SUBJECT: RFP No. 24-08 SOC Wall / Fencing and Guardhouse

ADDENDUM: Number 3

Project: **SOC SECURITY WALL / FENCING and GUARDHOUSE  
CONSTRUCTION PROJECT  
HCSO Proposal Number 24-08  
R&P Project No. 0807L**

**ADDENDUM NO. 3**

|  | <b>Rañon &amp; Partners, Inc.</b><br>Architects | <b>HILLSBOROUGH COUNTY SHERIFF'S OPERATIONS CENTER</b><br><b>SECURITY WALL / FENCING</b><br><b>AND GUARDHOUSE</b><br>TAMPA, FLORIDA | DWG.<br><b>2-A1.1-1</b><br>DATE: 02.13.09 |

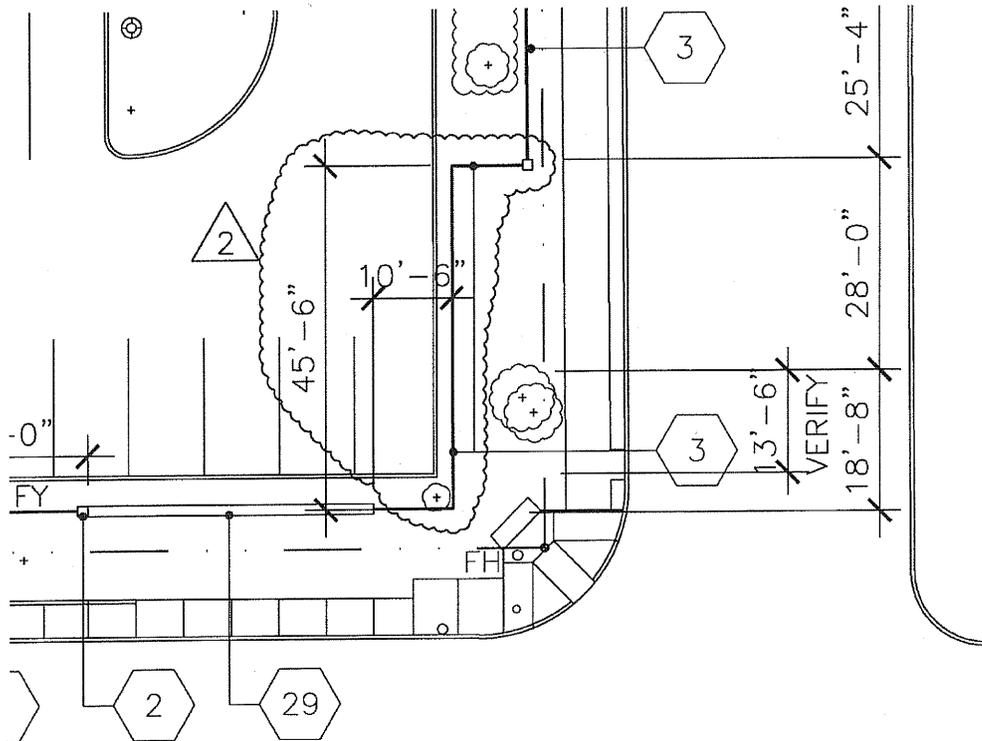
1. Revise location of wall and fencing at SE corner of site per Drawing 2-A1.1-1.
2. Revise location of wall and fencing along East side of site per Drawing 2-A1.1-2.
3. Relocate existing sanitary sewer cleanout at North side of site in conflict with new wall and/or fence.
